Re: **Docket No. 536 – Tarpon Towers III, LLC and Cellco Partnership d/b/a Verizon Wireless application for a Certificate of Environmental Compatibility and Public Need for the construction, maintenance and operation of a telecommunications facility located at 78 Goshen East Street in Norfolk, Connecticut**

RESPONSES OF TARPON TOWERS III, LLC AND CELLCO PARTNERSHIP D/B/A  
VERIZON WIRELESS TO  
CONNECTICUT SITING COUNCIL INTERROGATORIES

- Proposed Verizon Wireless Facility
- Existing and Proposed RSRP >=-85 (in building)
- Existing and Proposed RSRP >=-95 (vehicular)
- Existing Verizon Wireless Facilities
- Major Route
- Town Line

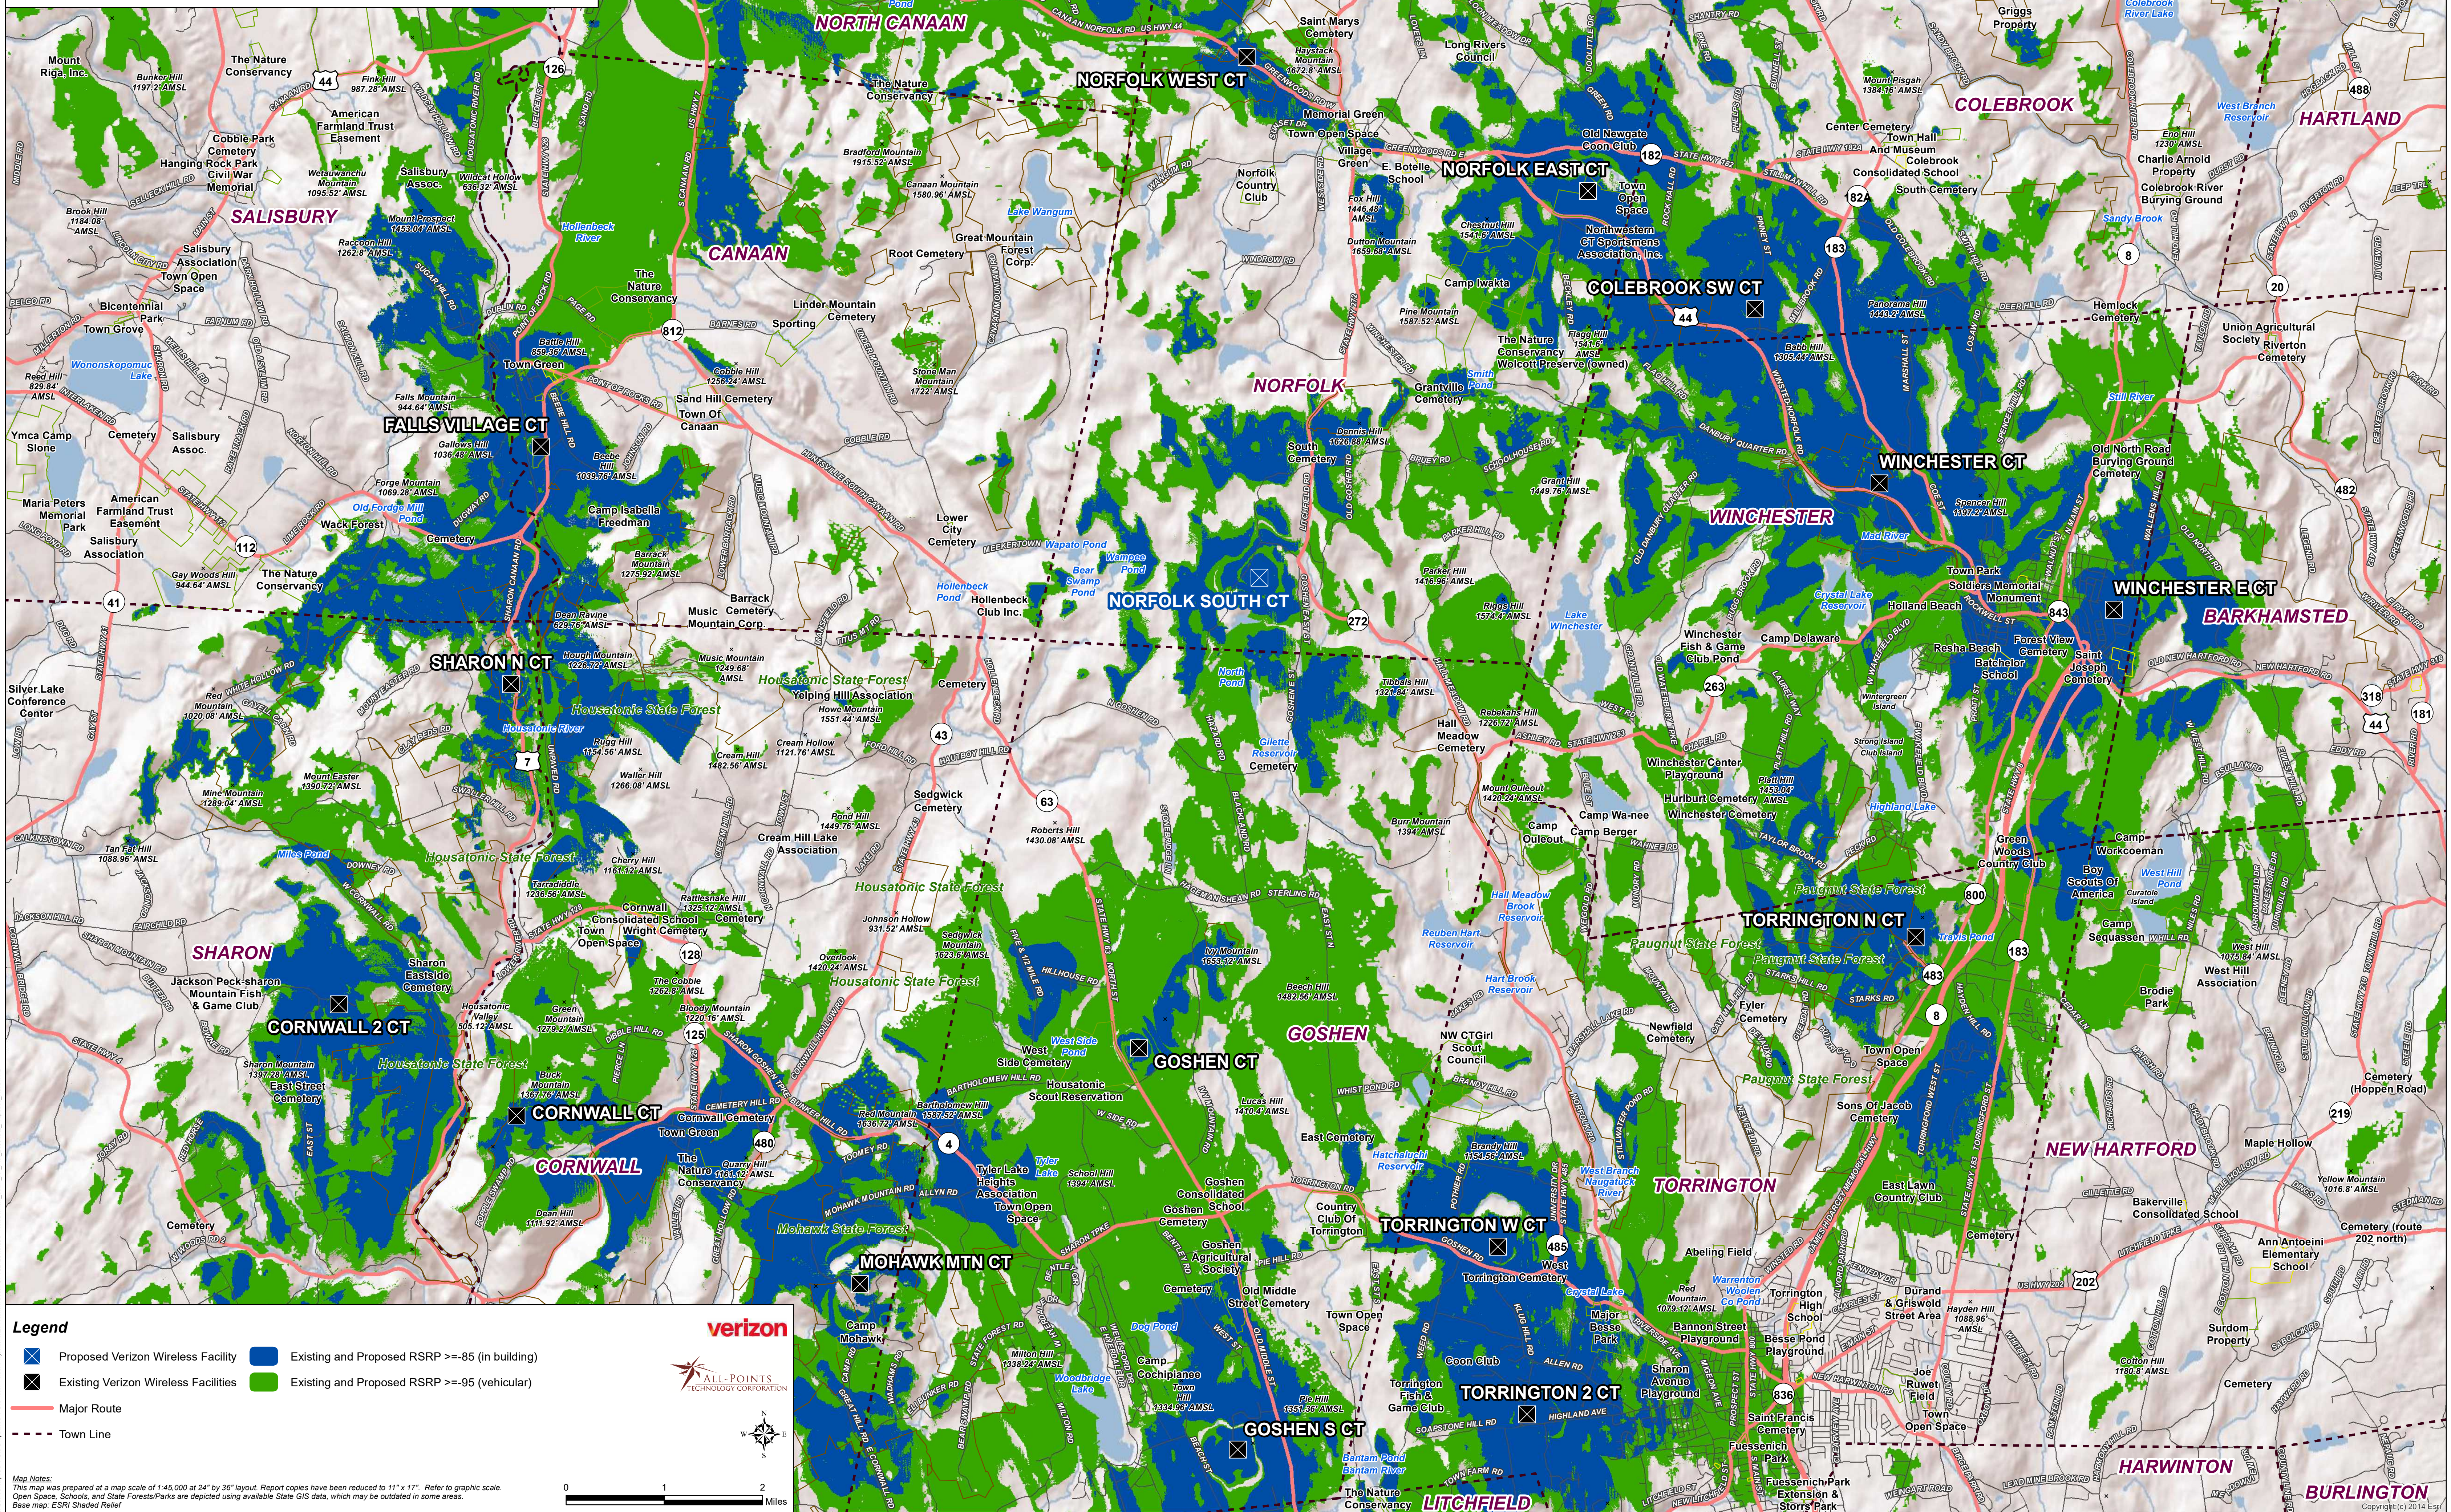
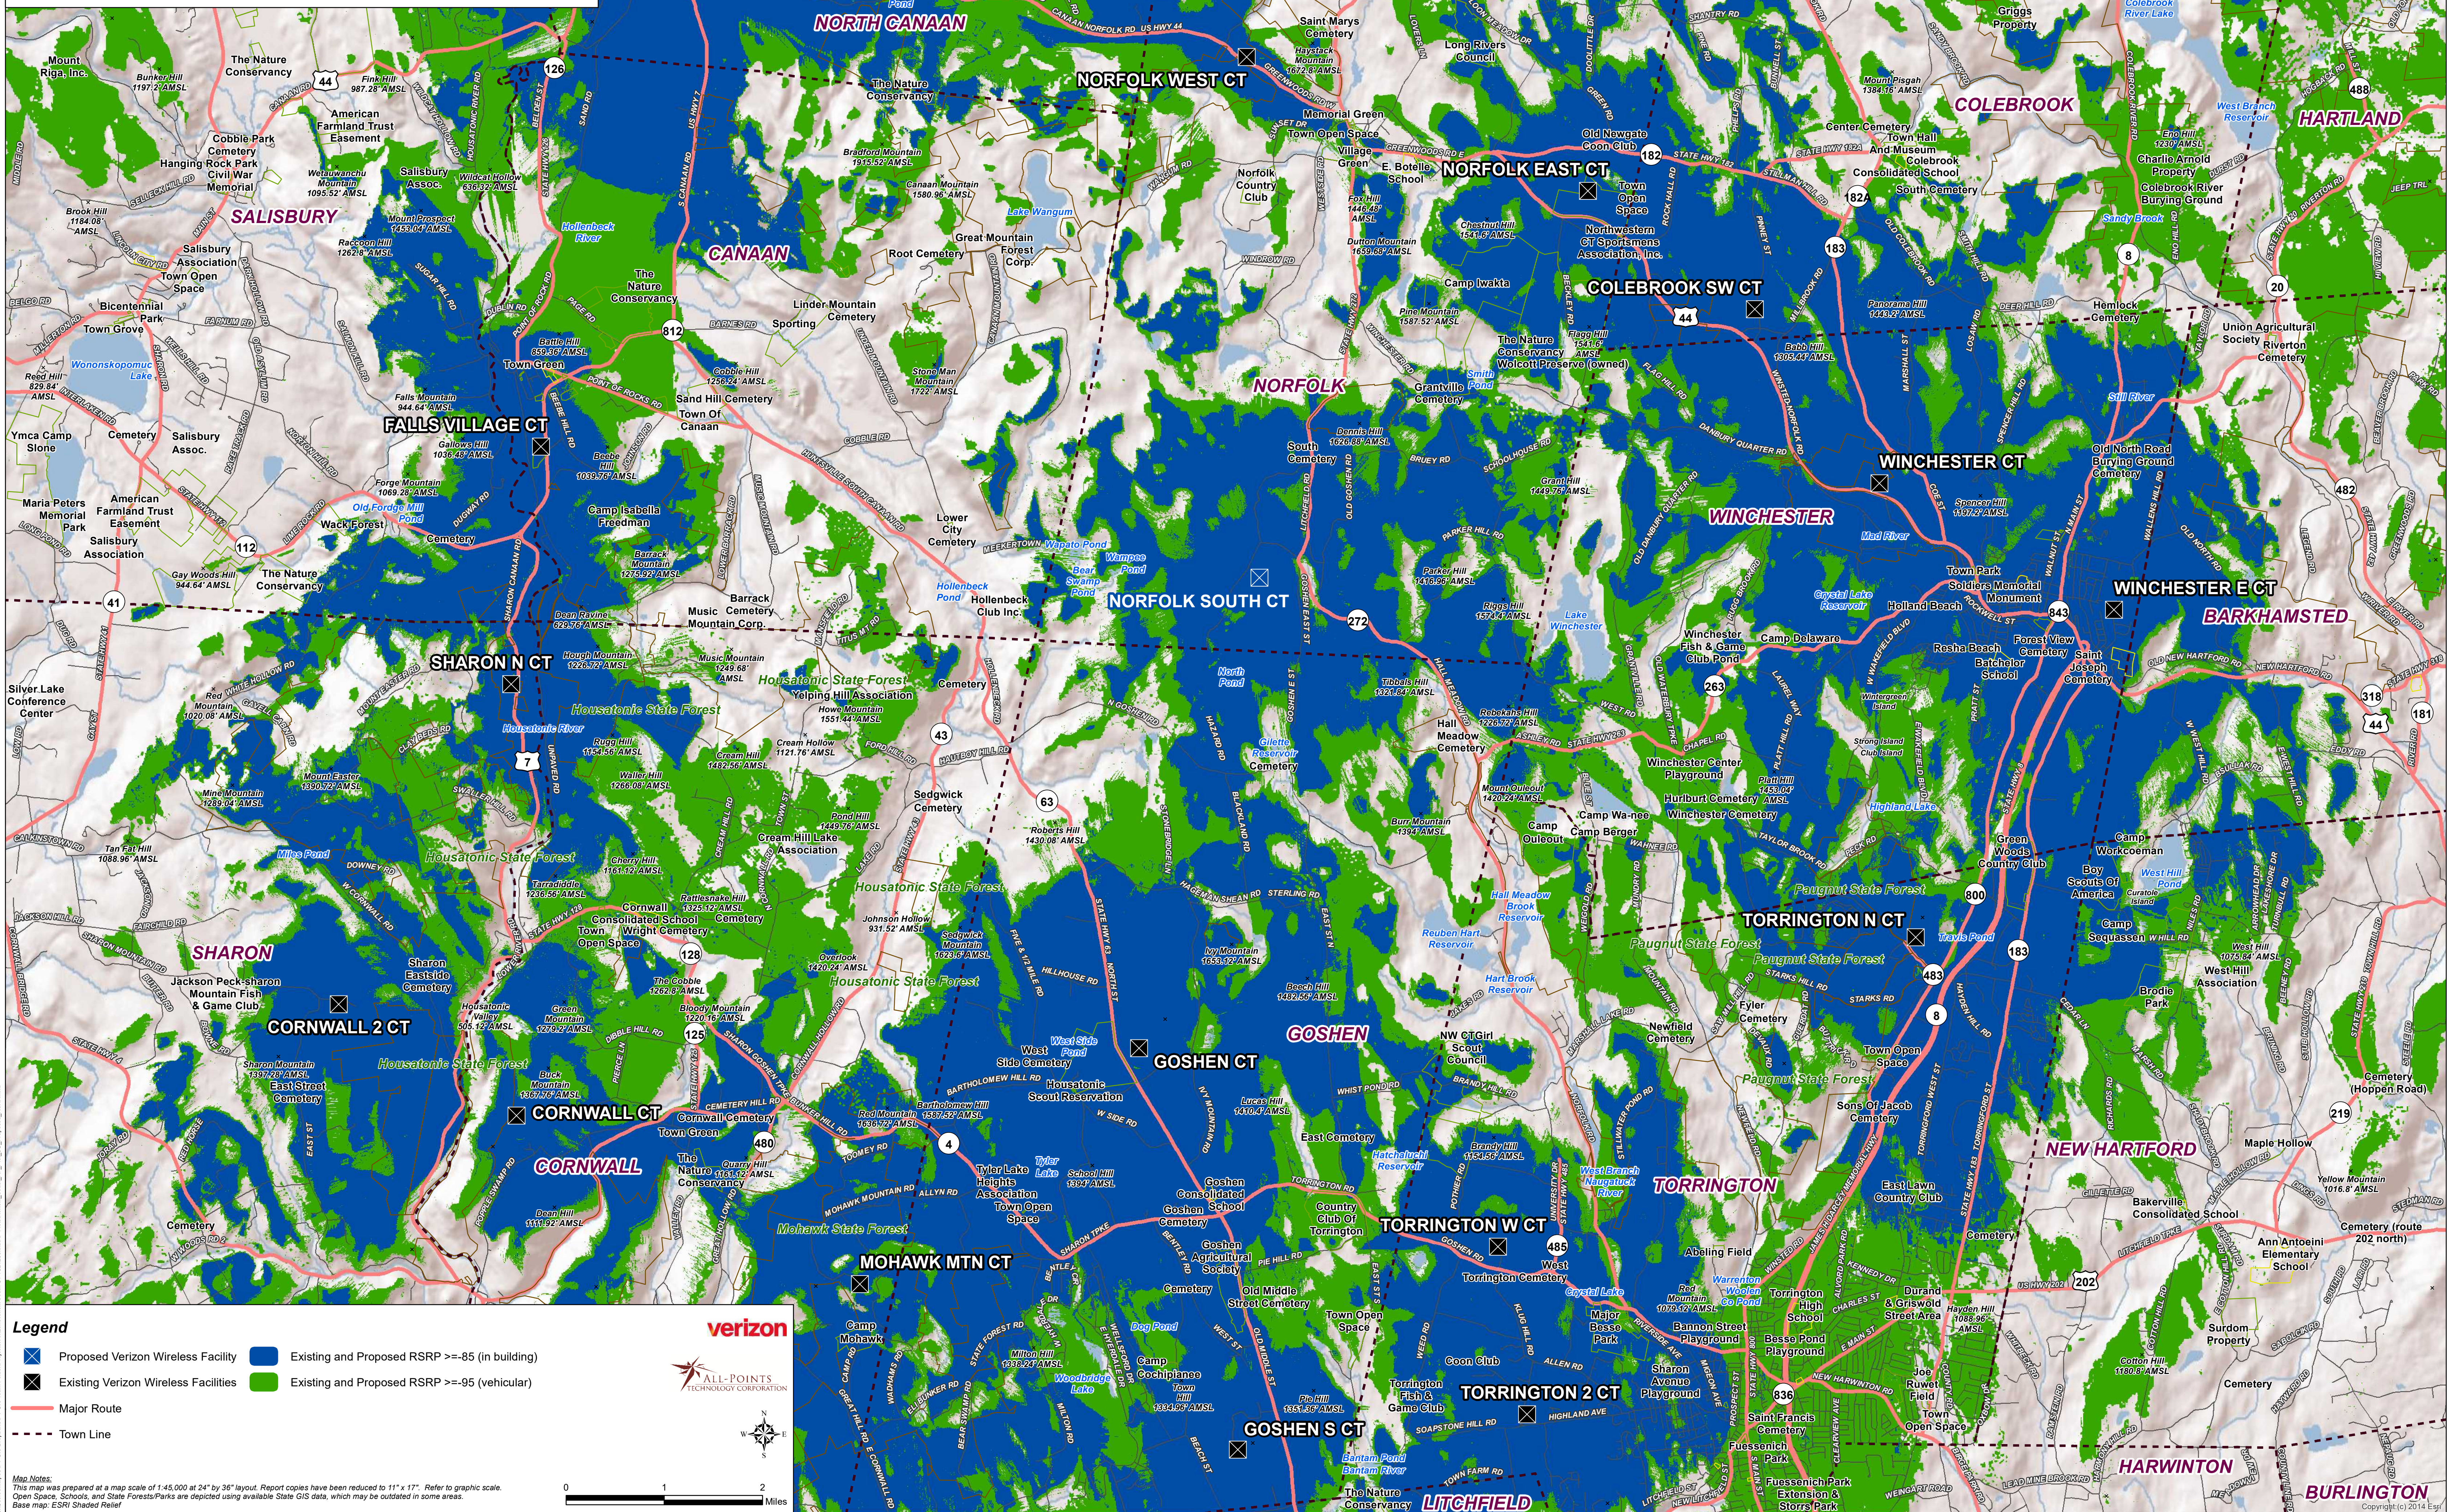
Referencing Application p. 8, what is the length of the service gaps on Routes 272 and 263?

In preparation for these interrogatories, discrepancies were noted in the coverage maps in Application Attachment 6 that appear to have overpredicted proposed service from the proposed Norfolk South Facility and the existing facilities in the area due to the inclusion of service at -105 dBm signal level. As the Council is aware, and as noted in response to Question No. 20 above, the -105 dBm signal level does not meet Cellco’s service reliability standard. The existing

and proposed coverage maps attached hereto as Exhibit 1 (Modified Existing and Proposed Coverage Maps) have been adjusted to show -85 dBm and -95 dBm signal levels from the proposed Norfolk South Facility and the existing facilities in the area. The responses to these interrogatories correspond directly to those modified existing and proposed coverage plots. No modifications to the “existing coverage” plots provided in Attachment 6 in the Application were required.

The existing gap in Cellco service along Route 272 is approximately 4.9 miles in the Norfolk and approximately 2.1 in Goshen. If approved, the Norfolk South Facility will fill the entire 4.9-mile gap in Norfolk and a 0.3-mile portion of the gap in Goshen.

The existing gaps in Cellco service along Route 263 consists of approximately 0.4 miles in Goshen and approximately 3.0 miles in Winchester. If approved, the Norfolk South Facility will fill a 0.3 mile portion of the gap in Goshen and approximately 2.3 mile portion of the gap in Winchester.

CT SITING COUNCIL DOCKET NO. 536  
RESPONSE TO INTERROGATORY #43  
NORFOLK SOUTH CT  
78 GOSHEN EAST STREET  
NORFOLK, CT

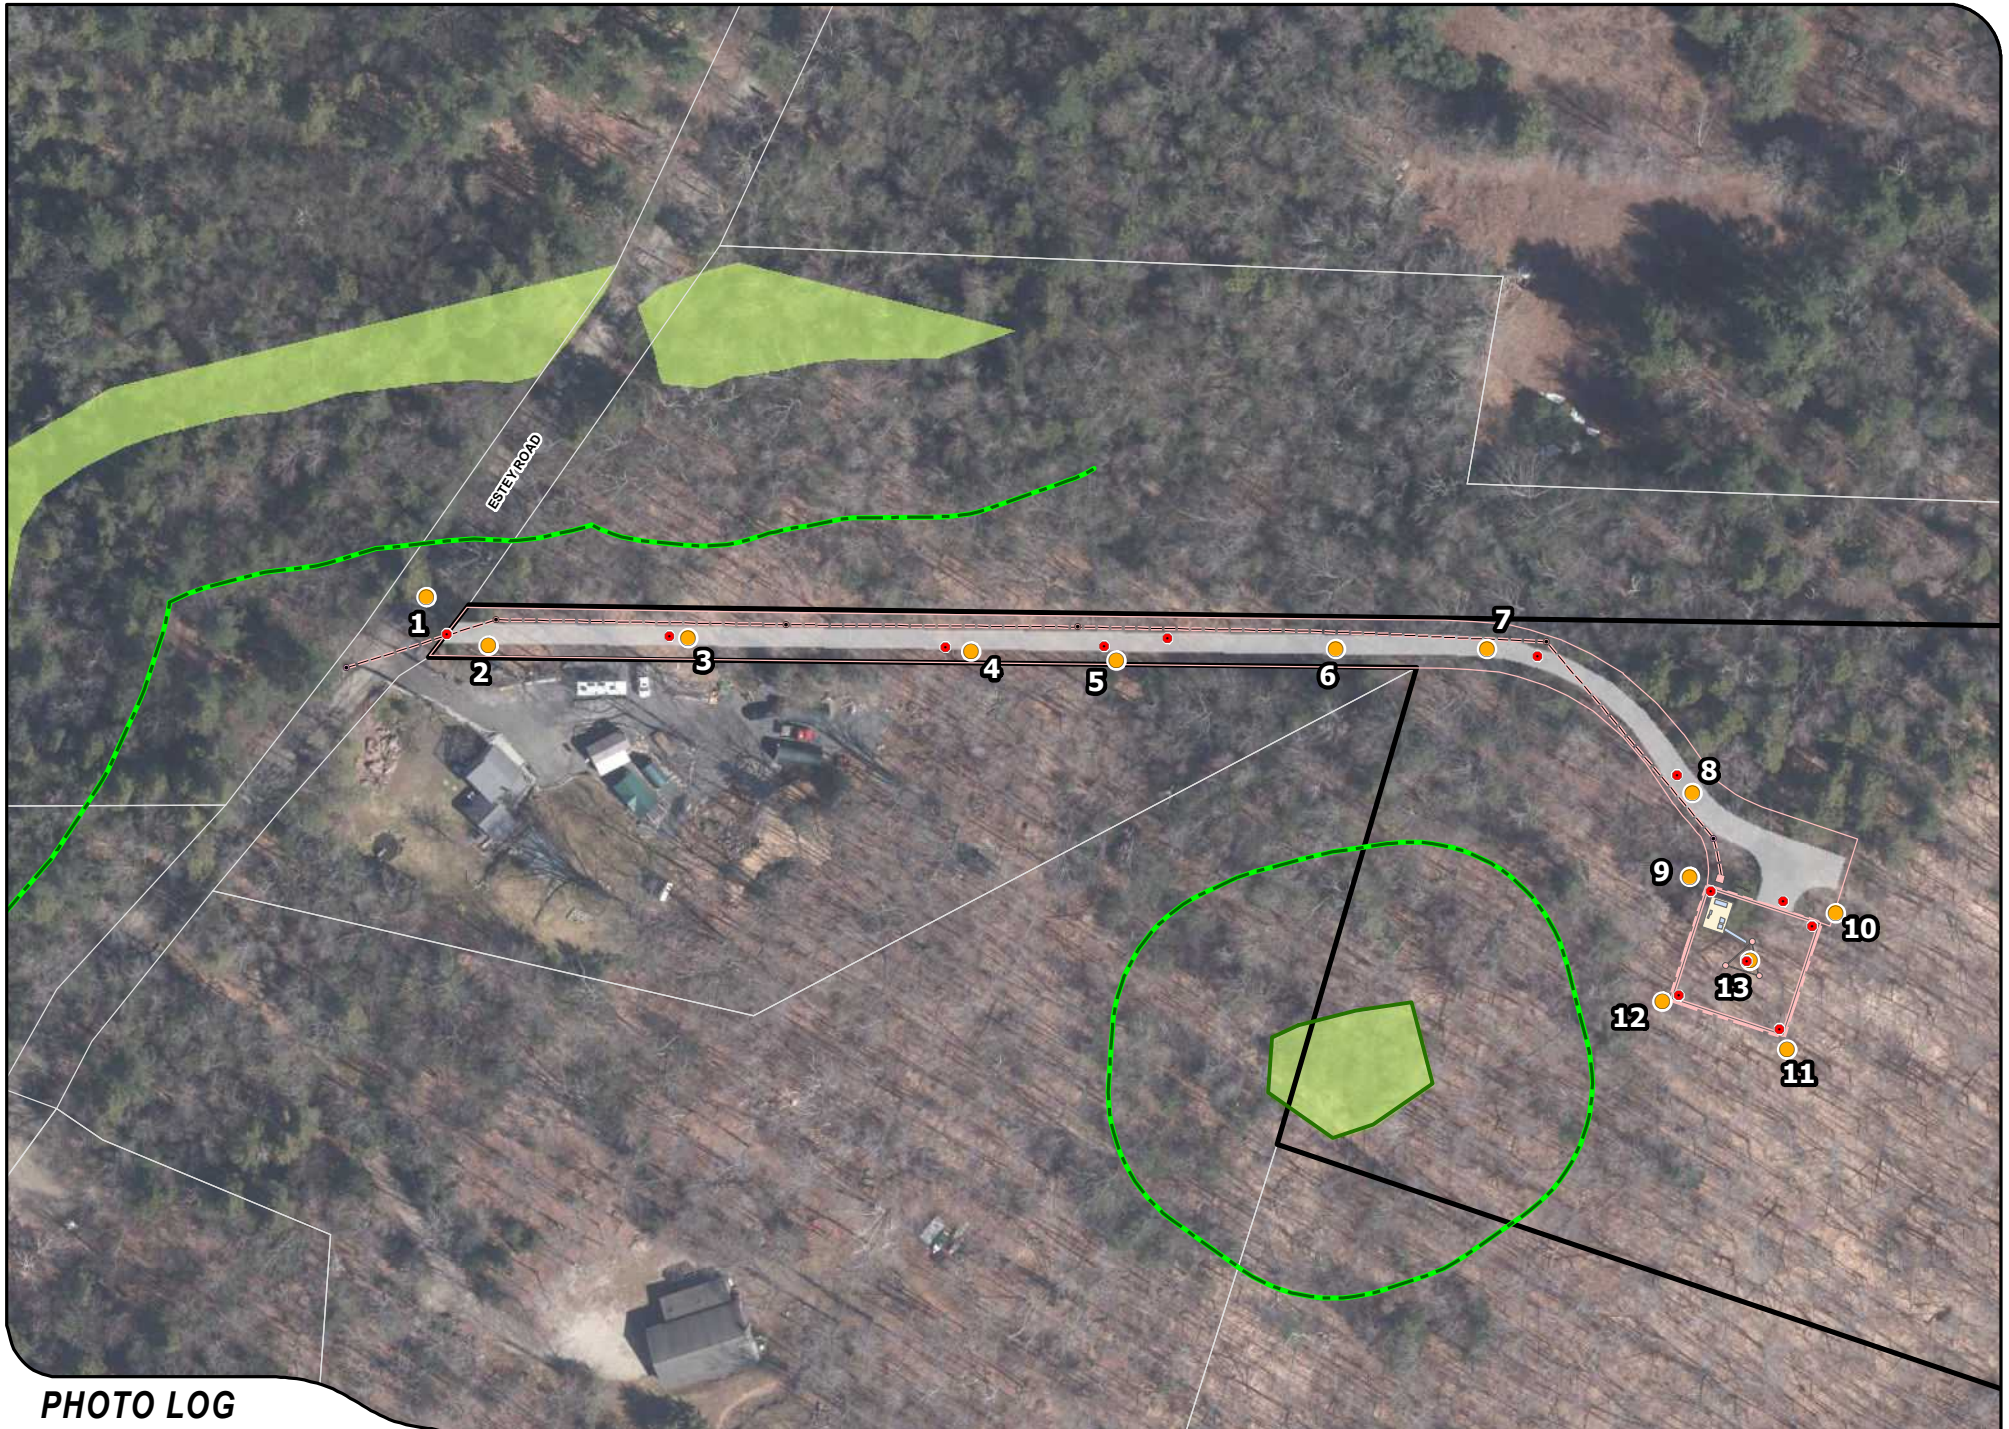
Submit photographic site documentation with notations linked to the site plans or a detailed aerial image that identifies locations of site-specific and representative site features. The submission should include photographs of the site from public road(s) or publicly accessible area(s) as well as Site-specific locations depicting site features including, but not necessarily limited to, the following locations as applicable:

See Exhibit 3 (*Remote Field View*), attached hereto.
